### NOTICE OF PROPOSED CHANGE IN PROPERTY

Petition: x1821

Petition: x1821  
**"REVISED"**

REQUEST TO OUTHRIGHT VACATE  
 VARIOUS PUBLIC STREETS AND ALLEYS AND  
 REQUEST ENCROACHMENT OF  
 BATES ST. AND A PORTION OF MONROE AVE. AND CADILLAC SQ.  
 IN THE AREA BOUND BY  
 MONROE AVE., RANDOLPH AND BATES ST.  
 AND CADILLAC SQUARE

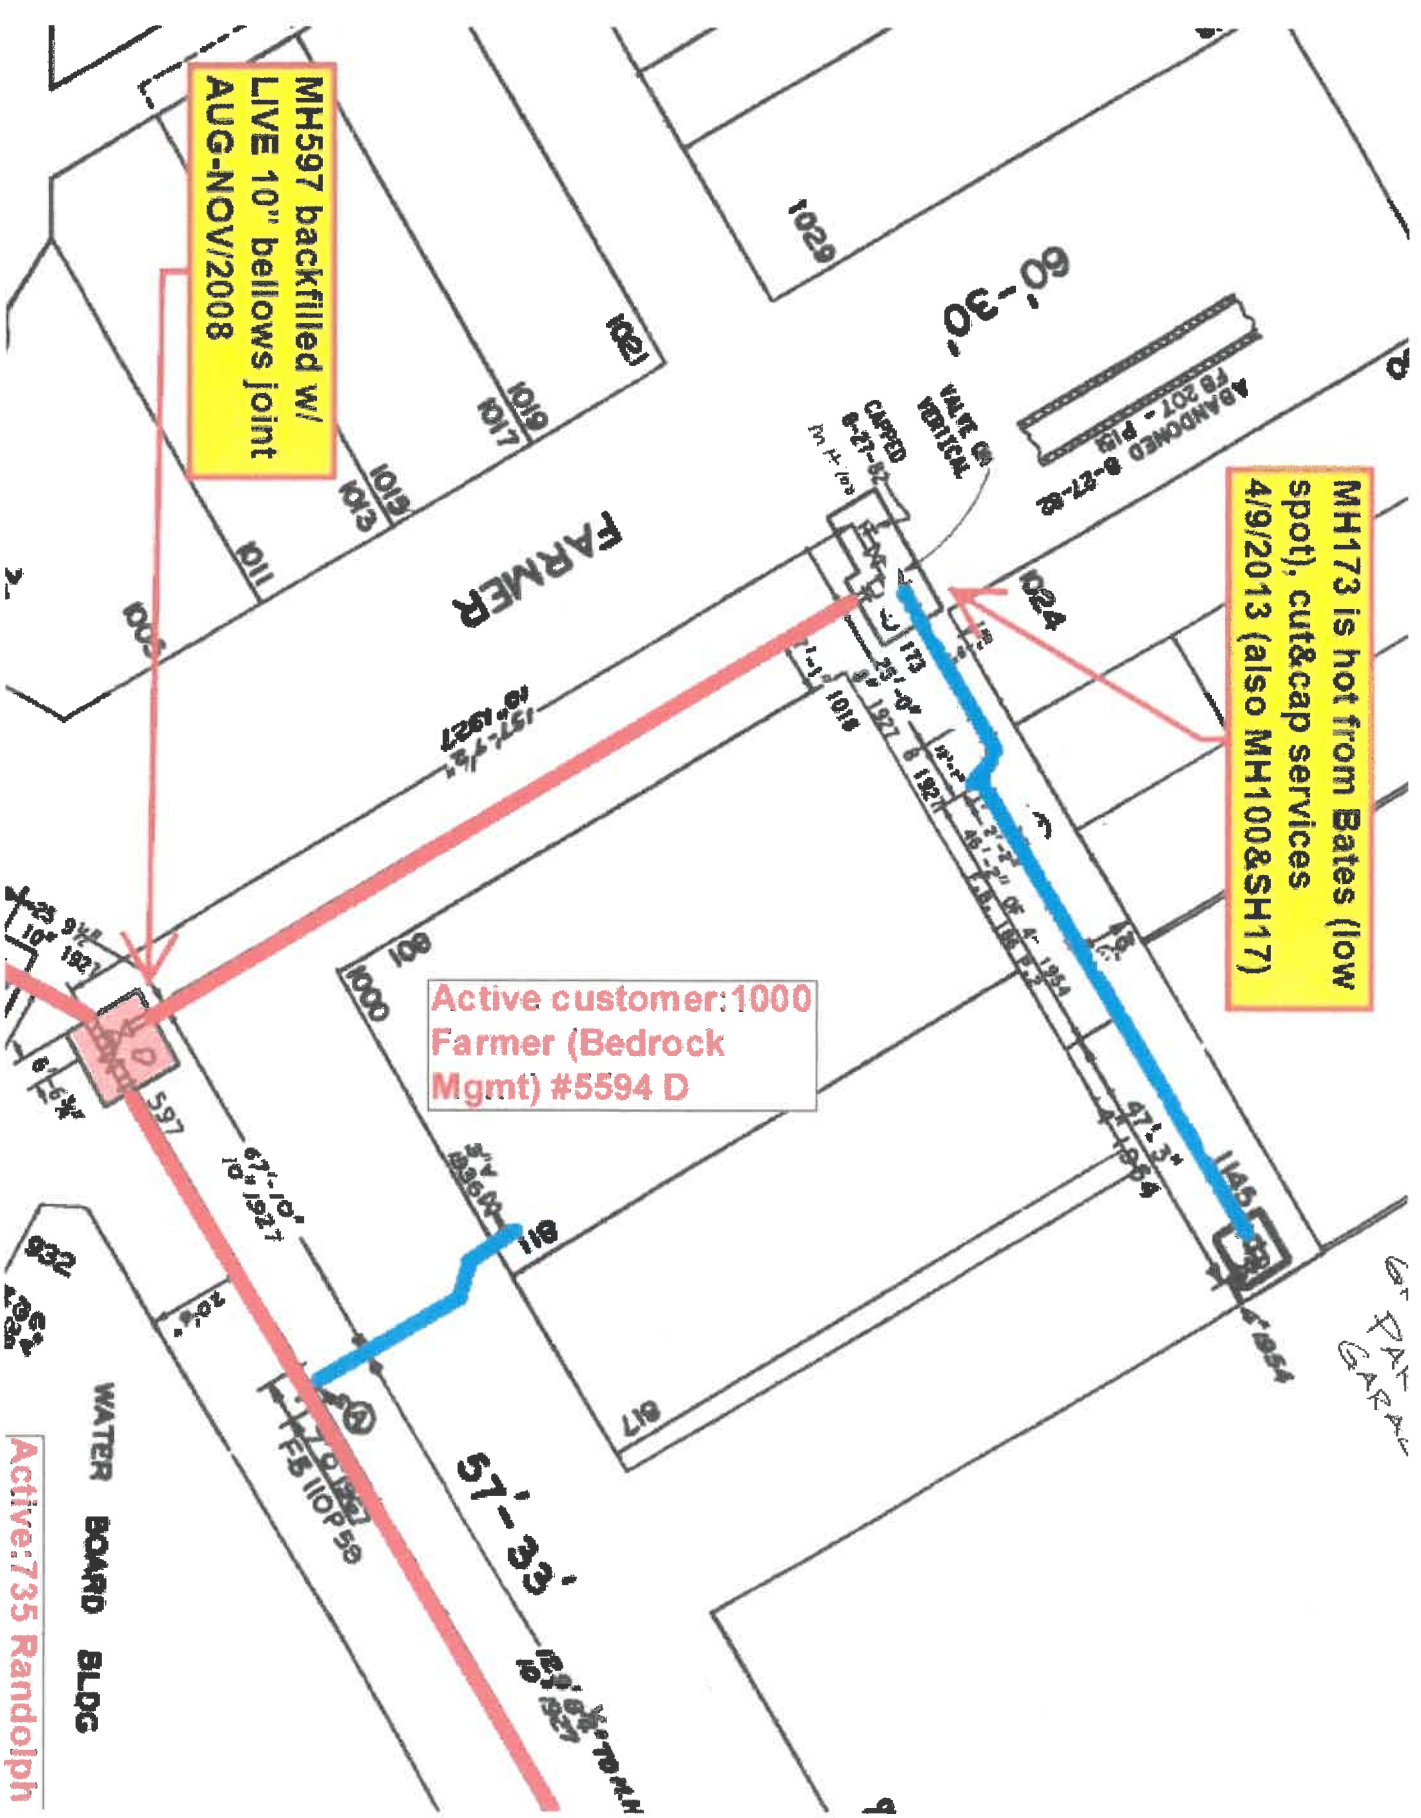
- Not Involved
- Involved; but asking you to hold action on this petition until further notice.
- Involved; but no objections to the property change.
- Involved; objection to the property change.
- Involved; but no objections to the property change...provided as easement of the full width of the public right-of-way (street, alley or other public place) is reserved.
- Involved; the nature of our services and the estimated costs of removing and/or rerouting such services are: TBD  
REQUEST MEETING WITH BEDROCK TO DISCUSS.

MH597 backfilled w/  
LIVE 10" bellows joint  
AUG-NOV/2008

MH173 is hot from Bates (low  
spot), cut&cap services  
4/9/2013 (also MH100&SH17)

Active customer: 1000  
Farmer (Bedrock  
Mgmt) #5594 D

Active: 735 Randolph
